Exhibit 5

Water Resource/Management District Correspondence

**North Plains Connector
Oliver County, ND
Schwalbe Dam**

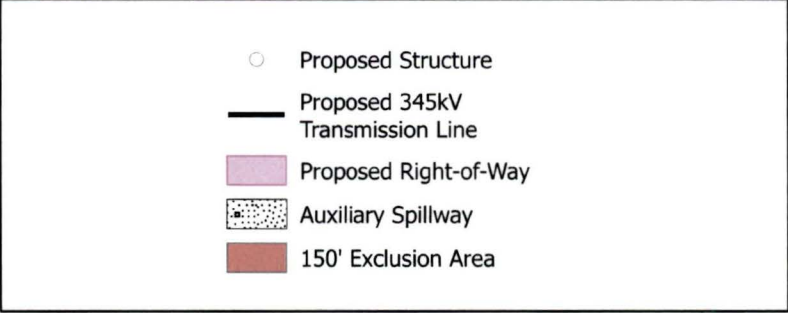
No concerns from me if sets backs are met.

This addresses all the proximity to the auxiliary concerns from the NRCS.

It's been awhile since the discussion with Brian but I believe the request was 150 ft from infrastructure related to the Dam in order to have clearance during emergency operations.

NRCS might have sent over the facility drawing for the setbacks. The revised route looks like it might be closer to the Dam but no longer within the auxiliary spillway.

Does the new route maintain the 150 ft clearance? Does NRCS have any additional concerns with the new route?

The project did obtain the facility drawings from NRCS and based all setbacks off that information. We are more than 150 feet back from all areas designated in the facility drawings and also removed the access roads from those areas.
